STAFF RECOMMENDATION 404 South 11th Street August 17, 2016

Application: New construction-addition; Setback determination
District: Lockeland Springs-East End Neighborhood Conservation Zoning Overlay
Council District: 06
Map and Parcel Number: 08313007900
Applicant: Gary Louden
Project Lead: Melissa.sajid@nashville.gov

Description of Project: The request is to construct a new rear addition and a side covered porch addition. The rear addition requires a left side setback determination from five feet (5') to two feet (2'). The request also includes covering the existing concrete block foundation with stone veneer.

RIGHT SIDE ELEVATION

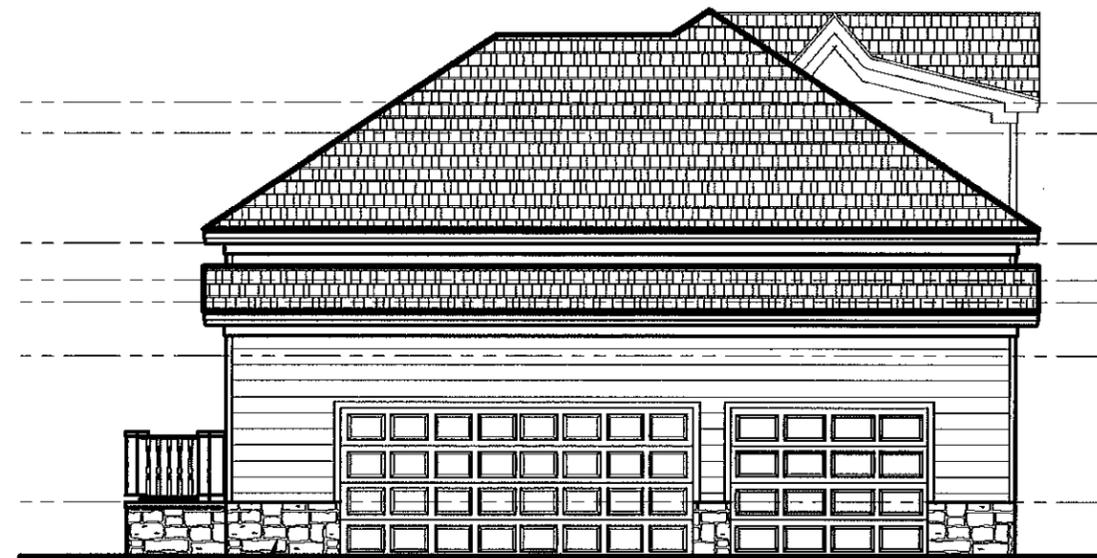
The request includes covering the existing concrete block foundation on the front and right side of the house with stone veneer that is approximately five-eighths inch (5/8") thick. The existing siding protrudes approximately one inch (1"), which is typical. Adding the stone veneer on top of the concrete foundation would not be appropriate as it would protrude slightly from the existing siding, which is not a historic condition.

1. The existing foundation shall not be covered by stone veneer;
2. Staff approve the final details, dimensions, and materials of the garage doors, trim, and roof material and color prior to purchase and installation; and
3. Staff approve the masonry color, dimensions and texture.
